Maule Aircraft Corporation

Service Letters #24, #25, #26, and #27

SERVICE LETTER NO. 26

Subject: Engine Top Baffle, Maule p/n 5031X-3, Installation.

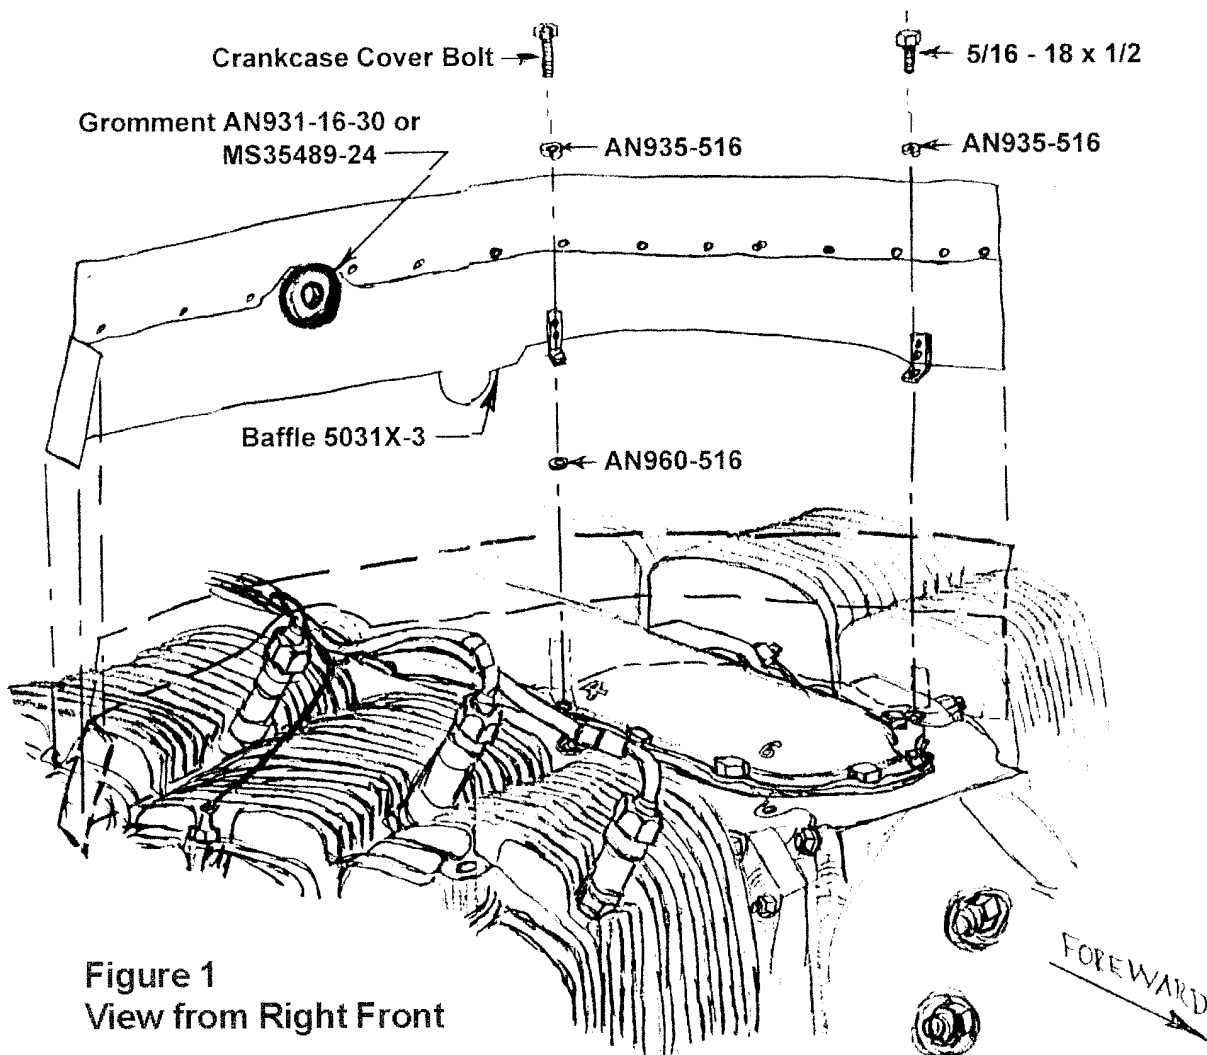
3. Install the rubber Grommet in the hole in the Baffle.
4. Remove the Top Crankcase Bolt as shown on Figure 1.
5. Install the Baffle in the position shown in Figure 1.

7. Use a Lock Washer p/n AN935-516, over the other Brace and secure with a 5/16 - 18 x 1/2" long Bolt to the Cylinder Base Temperature Probe Hole as shown in Figure 1.

Figure 2. View from Right Side

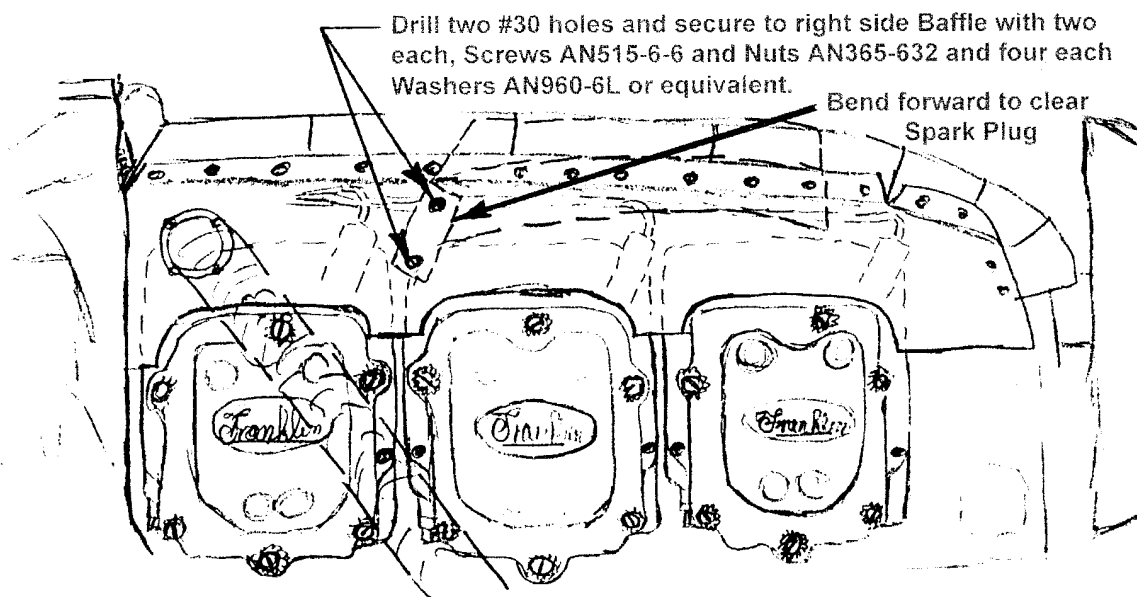
8. Form the Baffle to fit and attach it to the Right Side Baffle by drilling two #30 holes and securing with two each, Screws, p/n AN515-6-6, Nuts, p/n AN365-632, and four Washers, p/n AN960-6L, or equivalent as shown in figure 2.

LEFT ELEVATOR

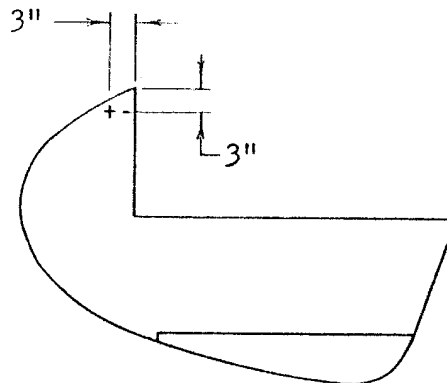
1. Place three (3) pound weight on left elevator as shown below.
2. With elevators in neutral position attach a scale accurate to $\pm 1/4$ pound to the Control Wheel Rim and pull gently and slowly forward (nose down direction) until the system starts to move. Record the greatest force required to move the Elevators.
3. Repeat Step 2 above pulling gently and slowly rearward (nose up direction) until the system starts to move. Record the greatest force required to move the Elevators.

4. The total of the nose up and nose down breakout friction obtained in Steps 2 and 3 above may not exceed 14 pounds.
5. Friction in excess of 14 pounds may be reduced by lubricating hinges in the elevators, control column base, control column wheel universal joints, control column nylon guide bushing, and lubricating and readjusting the tension in the control column sliding friction blocks.

Figure 1
View from Right Front

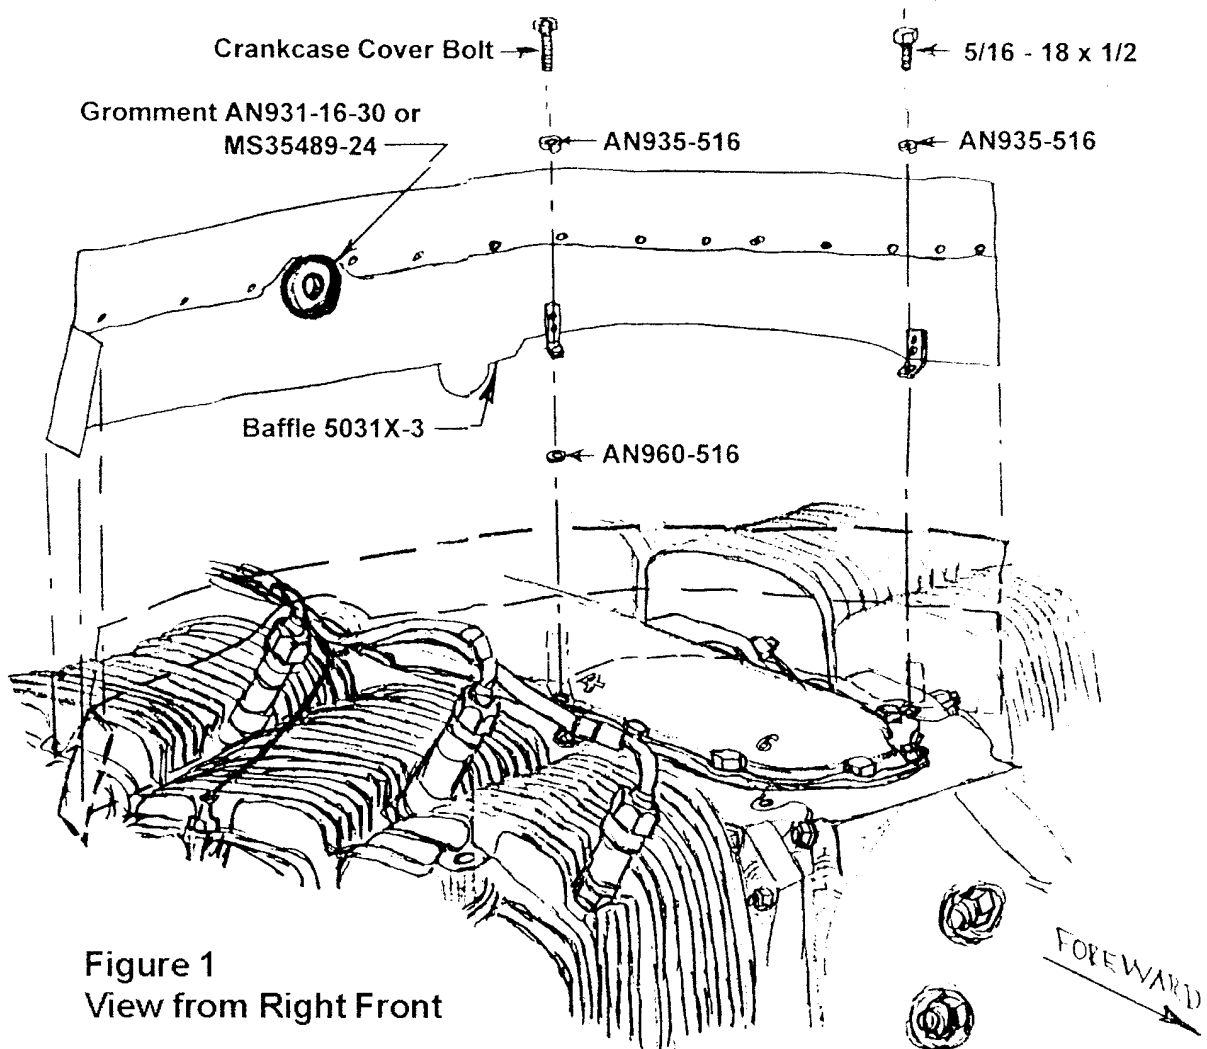
3. Install the rubber Grommet in the hole in the Baffle.
4. Remove the Top Crankcase Bolt as shown on Figure 1.
5. Install the Baffle in the position shown in Figure 1.

7. Use a Lock Washer p/n AN935-516, over the other Brace and secure with a 5/16 - 18 x 1/2" long Bolt to the Cylinder Base Temperature Probe Hole as shown in Figure 1.

Figure 2. View from Right Side

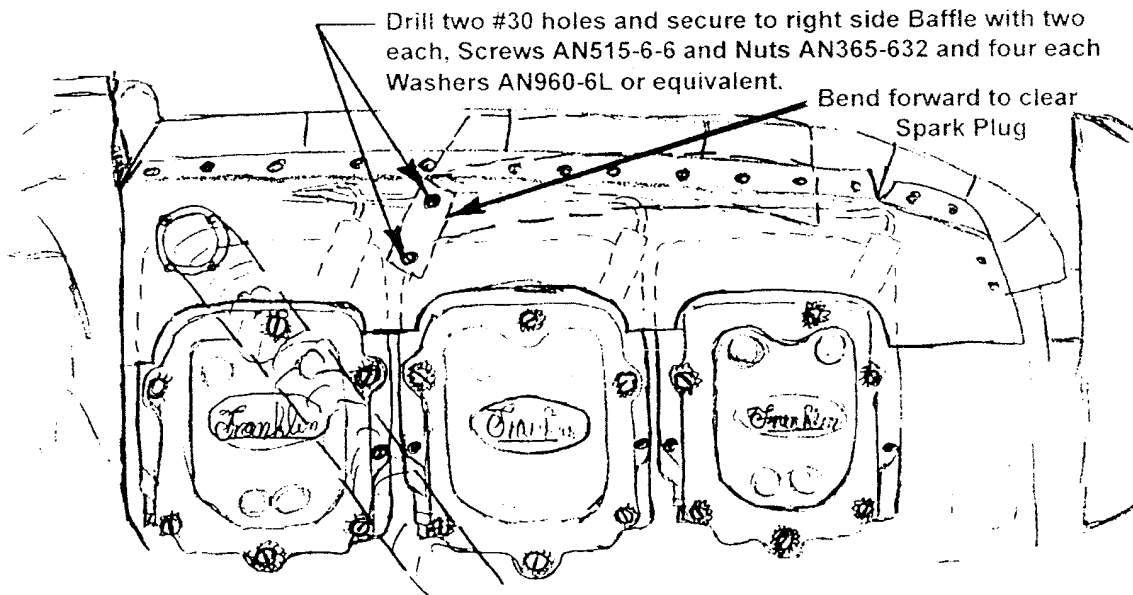
8. Form the Baffle to fit and attach it to the Right Side Baffle by drilling two #30 holes and securing with two each, Screws, p/n AN515-6-6, Nuts, p/n AN365-632, and four Washers, p/n AN960-6L, or equivalent as shown in figure 2.

LEFT ELEVATOR

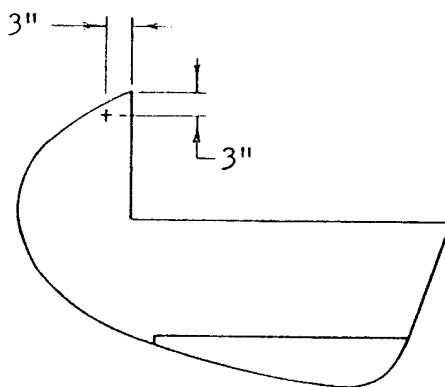
- II. Check Elevator Control System Friction as follows:
 1. Place three (3) pound weight on left elevator as shown below.
 2. With elevators in neutral position attach a scale accurate to $\pm 1/4$ pound to the Control Wheel Rim and pull gently and slowly forward (nose down direction) until the system starts to move. Record the greatest force required to move the Elevators.
 3. Repeat Step 2 above pulling gently and slowly rearward (nose up direction) until the system starts to move. Record the greatest force required to move the Elevators.

4. The total of the nose up and nose down breakout friction obtained in Steps 2 and 3 above may not exceed 14 pounds.
5. Friction in excess of 14 pounds may be reduced by lubricating hinges in the elevators, control column base, control column wheel universal joints, control column nylon guide bushing, and lubricating and readjusting the tension in the control column sliding friction blocks.
